**Residential Development, Cornelscourt, Dublin 18**

**Preliminary Design Stage Quality Audit**

**Report Ref:** p180208-Rep-009

#### 4.1.3 Problem G3 – Surface Drainage.

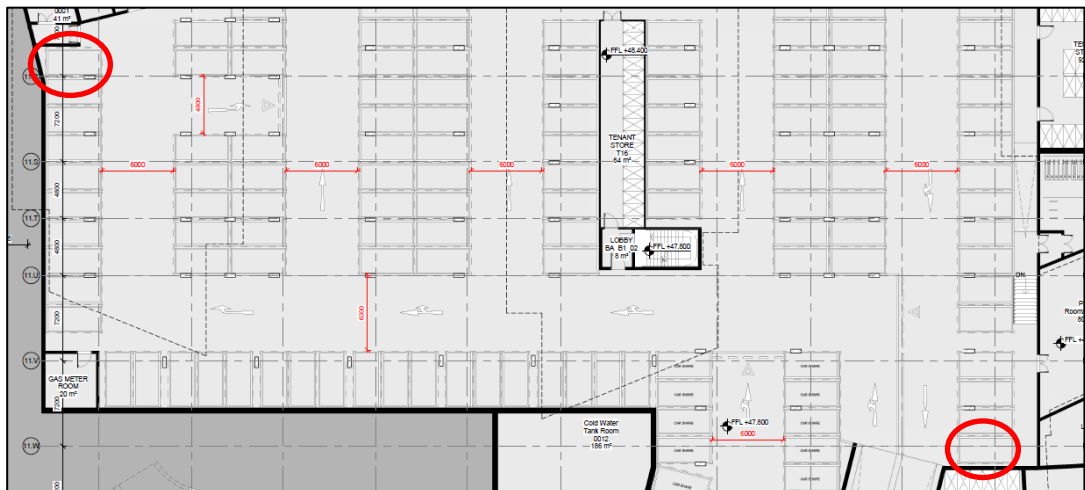
From the scheme information provided for this audit it has not been possible to ascertain the specific details of the surface drainage strategy. Surface water can prove a trip hazard in both warm and cold weather conditions in addition to adversely impacting the skid resistance of bicycles and motorized vehicles.

During the detail design stage ensure adequate measures are taken to ensure that the ramp has sufficient drainage and that localised ponding does not arise during wet weather conditions. All access routes leading to/from the subject site should have adequate surface water drainage.

**4.1.5 Problem G5 – Servicing Arrangement**

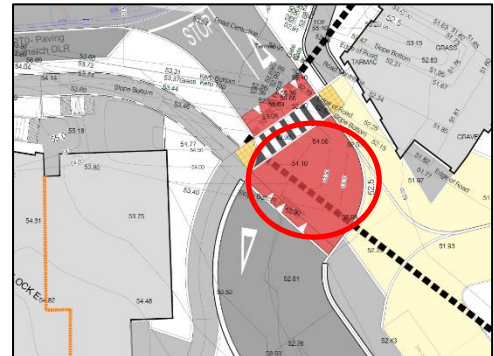
The auditors are unclear about the servicing arrangements (refuge collections) for the proposed development. Inappropriate practices in regard to; (i) temporary wheelie bin storage at surface level (e.g. temporary transfer area) which could block pedestrian and vehicle routes, (ii) method of transfer of large wheelie bins from the basement store to the surface on waste collection days (a single person pushing the bins up a 1:10 ramp would be considered dangerous), and (iii) refuge

vehicles access requirements and the potential for reversing in areas were conflicts with other vehicles, cyclists and pedestrians may arise.

The designers should confirm the arrangements being considered for refuge collections for the subject site, associated bin storage (permanent/temporary on day of collection) and refuge vehicle access/egress arrangements to all bin storage areas. A swept path analysis along the proposed servicing route should be undertaken.

### 4.2.2 Problem S2 - Zebra Crossing Markings & Buff coloured Tactile Paving

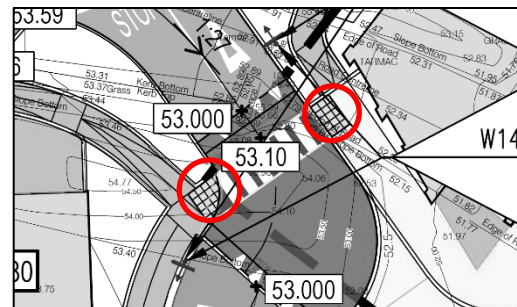
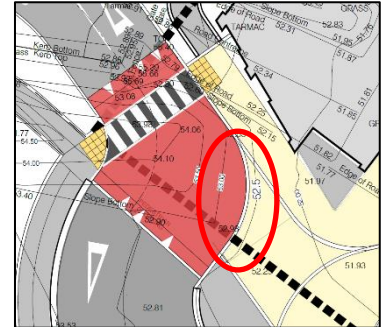
The audit team have noted the use of zebra crossing road markings with buff coloured tactile paving. The zebra crossing road marking indicate that pedestrians have priority at the crossing and vehicle drivers must stop. However,

the use of buff tactile paving (and the associated configuration) indicates that the crossing is an uncontrolled crossing. The use of the zebra road markings with buff tactile may cause confusion to both pedestrians and vehicle drivers as to who has priority, there is potential for pedestrian and vehicle conflict.

It is recommended that the zebra markings with illuminated beacons are supplemented with the appropriate red tactile (and the associated configuration) and the regulatory lines (transverse & zig zag) in accordance with the requirements of the Traffic Signs Manual.

#### 4.2.4 Problem S4 - Proposed Site Access Junctions

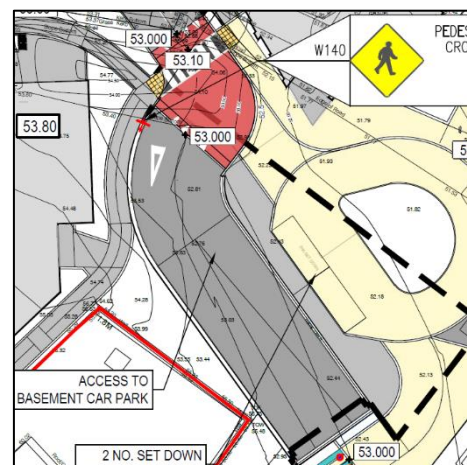
Parking restrictions (barrier or bollards) to the basement, to prevent access for non-residents have not been provided. During the site visit it was observed that cars were parked haphazardly on the southern side of the access. The auditors are concerned that non-residents such as AIB customers may park (i) in the basement or (ii) at the podium level courtyard. Such practices could result in residents having to park haphazardly on the surface level footpaths/shared surface, which could lead to vulnerable road users having to enter the carriageway leading to greater likelihood of conflict with motorised vehicles or could lead to slip and fall as pedestrians mount/dismount kerbs or walk through grassed area.

Ensure appropriate self-enforcing measures are put in place to prevent non-residential vehicles from accessing the basement car park and central podium level 'shared' courtyard area.

**4.2.5 Problem S5 – Pedestrian/Cycle route approaching the zebra crossing**

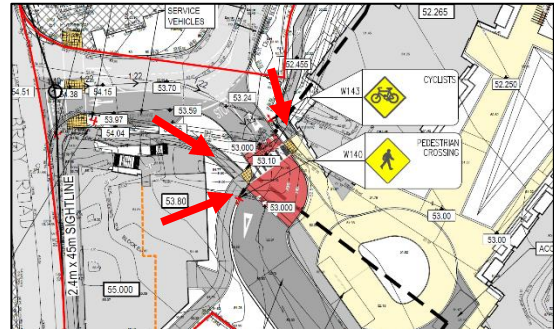
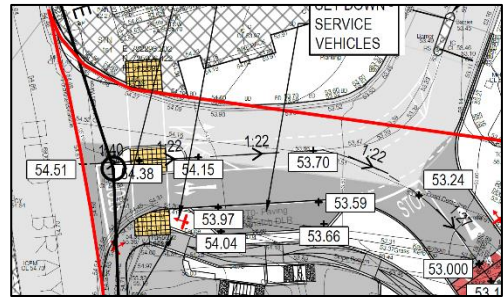
The auditors are unsure if the three paths approaching the zebra crossing are pedestrian footpaths or shared pedestrian/cycle routes? The cyclist warning sign (W143) prior to the crossing, would give the impression that they are shared

pedestrian/cycle routes. If these are shared pedestrian/cycle routes, they appear to be of inadequate width. These shared pedestrian/cycle routes could result in pedestrians/cyclists competing for space and increase the risk of pedestrian/cyclist collisions.

Ensure the pedestrian/cycle routes are an appropriate width to cater for the anticipated level of pedestrian and cyclist demand. The effective width of the pedestrian/cycle link should meet the width requirements for shared facilities in accordance with the National Cycle Manual.

#### 4.2.7 Problem S7 – Surface Level 'Set Down' Area

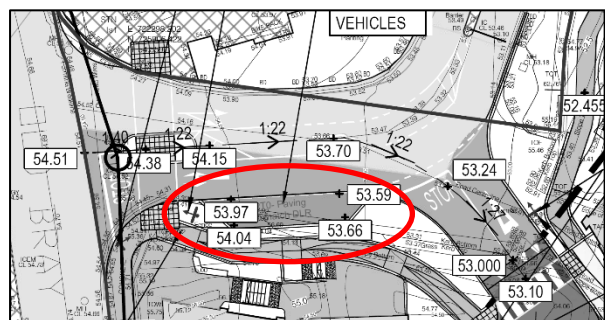
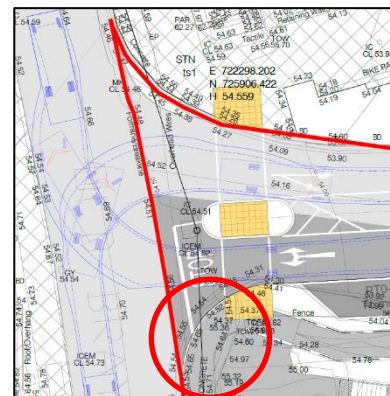
An indented kerbside layby facility is proposed on the southern side of the internal access between the Old Bray Rd junction and the access routes to/from the proposed residential development. The auditors

request clarification regarding how the adopted design vehicle can conveniently gain safe access into or from this kerbside facility without the need to undertake

a three point (or more depending upon vehicle type) u-turn manoeuvre on the internal road carriageway in the general area where the access roads diverts to the northwest (AIB car park) and southeast (development basement car park – podium access). Vehicle drivers undertaking turning manoeuvres in this general area could come into conflict with other vehicles or result in localised congestion leading to a queue of inbound vehicles extending back onto the Old Bray Road carriageway (where the potential for rear-end shunt incidents increases).

Clarification is required outlining how safe and convenient vehicle access can be achieved to the proposed kerbside layby facility in its present location. Should it prove difficult to achieve a safe and convenient access arrangement (e.g. one that does not require a u-turn manoeuvre on the main internal vehicle road carriageway) it is recommended that the kerbside bay is relocated to an appropriate location on Old Bray Road. Appropriate regulations may also need to be implemented to safeguard the availability of the kerbside bay (for its intended function) considering the existing demand at the neighbouring AIB facility.

#### 4.2.9 Problem S9 – Haphazard parking on Bray Road at AIB access junction

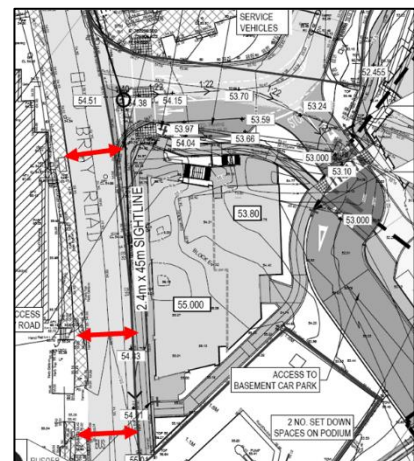
During the site visit it was observed that cars were parked haphazardly on the southern side of the access. The auditors are concerned that due to the new junction layout, vehicles will no longer be able to park on the southern side of the existing AIB access and may decide to park along the eastern side of Bray road in close

proximity to the junction. Haphazard parked cars along Bray Road at the AIB access junction may obstruct driver's visibility at the junctions. Failure to provide sufficient visibility for vehicle drivers at the junctions could result in overshoot incidents or side impact collisions with vehicles/cyclists travelling along the road.

The existing double yellow lines along the eastern side of Bray Road should be extended to prevent vehicles parking at the AIB access junction. Ensure sufficient visibility is provided at junction.

#### 4.2.13 Problem S13 – Basement Carpark wide carriageway widths

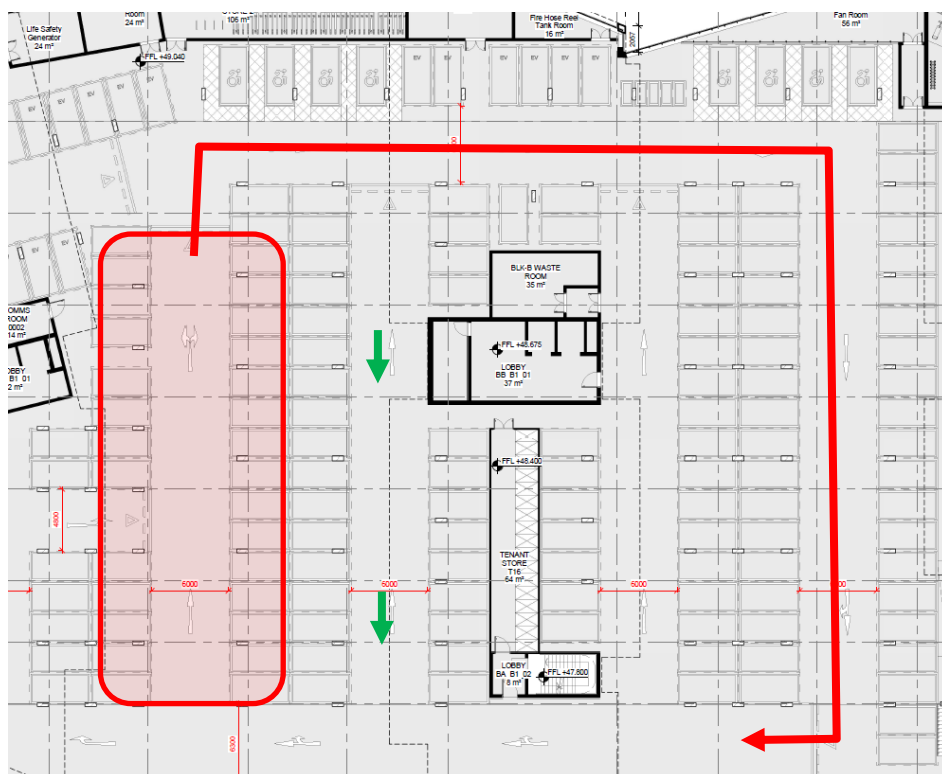
The basement has a number of wide 6.0-6.3m one-way vehicular routes, which may encourage excessive speeds, which could result in serious collisions if they strike pedestrians.

It is recommended that flush pedestrian / defensible walkways are provided either side of the carriageway to reduce the perceived width of the carriageway, while still providing the minimum width of 6m between perpendicular parking bays for manoeuvrability.

#### 4.2.15 **Problem S15 – Access to the lower level of the basement Carpark**

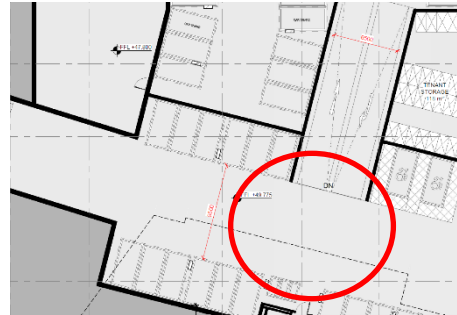
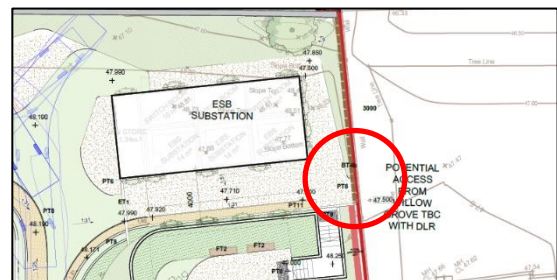
The access/egress route to/from the lower level of the basement car park is not very clear, particularly due to the very wide 9.6m two-way carriageway on approach to the lower level ramp. There is a risk of driver confusion and possible side-swipe collisions between vehicles.

There is also no regulatory road markings provided at this junction, such as a 'Stop' or 'Yield' road markings. This could lead to drivers being unaware of the priority and may result in collision with vehicles on main road.

It is recommended that appropriate wayfinding signage and road markings are provided to clearly outline the route to the lower level of the basement. Sufficient visibility splays should be safeguarded at all internal junctions within the basement car park facility.

The regulatory road markings should be provided at the access junction in accordance with the requirements of the Traffic Signs Manual.

#### 4.2.17 Problem S17 – Shared Surface along the N11

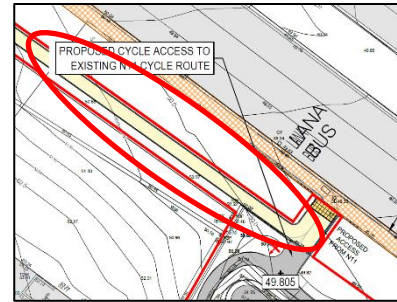
The shared two-way pedestrian/cycle route along the N11 appears to be of inadequate width. This pedestrian/cycle route could result in pedestrians/cyclists competing for space and increase the risk of pedestrian/cyclist collisions.

Ensure the pedestrian/cycle route is an appropriate width to cater for the anticipated level of pedestrian and cyclist demand. The effective width of the pedestrian/cycle link should meet the width requirements for shared facilities in accordance with the National Cycle Manual.

#### 4.2.18 Problem S18 - Tactile Paving at Start and End of Shared Surface

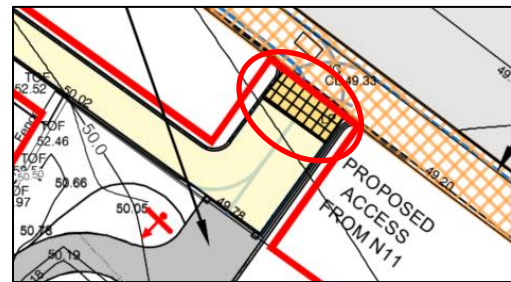
The audit team have noted the use of tactile paving at the start and end of the shared surface approaching the cycle lane along the N11. The use of blister tactile paving may be misleading to blind or partially sighted pedestrians who may feel that they are at a crossing point.

It is recommended that ladder type corduroy tactile paving is provided at the start and end of the shared use surface.

#### 4.2.19 Problem S19 – Inter-visibility basement car park

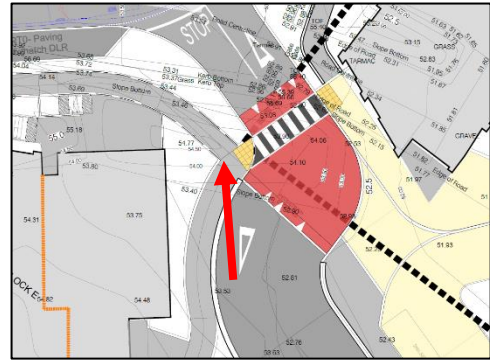
There is a pedestrian crossing route in close proximity to the entrance to the basement car park. It is unclear if there will be sufficient inter-visibility between pedestrians and drivers due to the presence of the wall/structure adversely impacting exiting vehicle drivers.

It is recommended that sufficient inter-visibility be provided on the approaches to the proposed zebra crossing. The pedestrian crossing could be shifted further north to provide sufficient visibility while also ensuring vehicles approach the crossing more perpendicular.

#### 4.2.20 Problem S20 – Pedestrian desire line/crossing

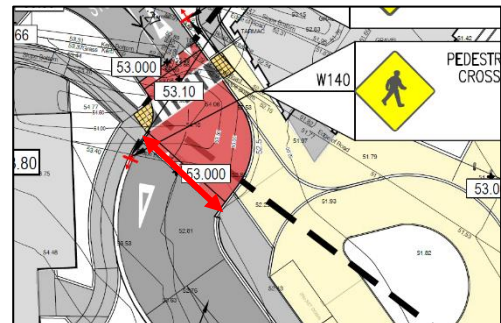
The Audit team have concerns that pedestrians may attempt to cross the basement access road along the immediate crossing desire lines to/from the footpath at the set down area (see in schematic). The steep crossfall of the ramp is along this pedestrian desire line, which may lead to pedestrian trips/falls.

It is recommended that the crossfall of the ramp is relocated outside of the pedestrian desire line and an appropriate pedestrian crossing is provided with tactile paving.

#### 4.2.21 Problem S21 – Pedestrian/Cycle route

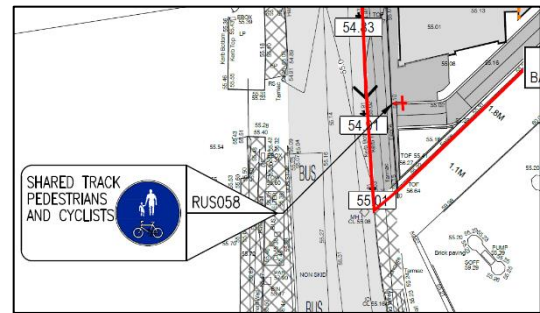
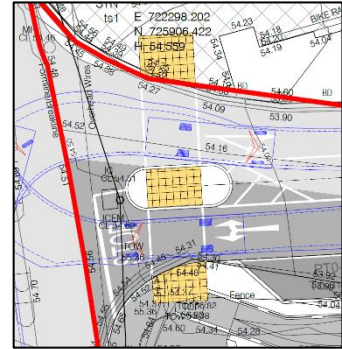
The auditors are unsure if the path approaching the zebra crossing is a pedestrian footpath, shared pedestrian/cycle routes or segregated footpath/cycle route (due to centreline)? If this is a shared

pedestrian/cycle routes or segregated footpath/cycle route, it would appear to be of inadequate width. This shared pedestrian/cycle routes could result in pedestrians/cyclists competing for space and increase the risk of pedestrian/cyclist collisions. Also, warning tactile paving has not been provided on approach to the existing footpath along the Old Bray Road.

Ensure the pedestrian/cycle routes are an appropriate width to cater for the anticipated level of pedestrian and cyclist demand. The effective width of the pedestrian/cycle link should meet the width requirements for shared facilities in accordance with the National Cycle Manual. Ensure the appropriate warning tactile paving is provided.
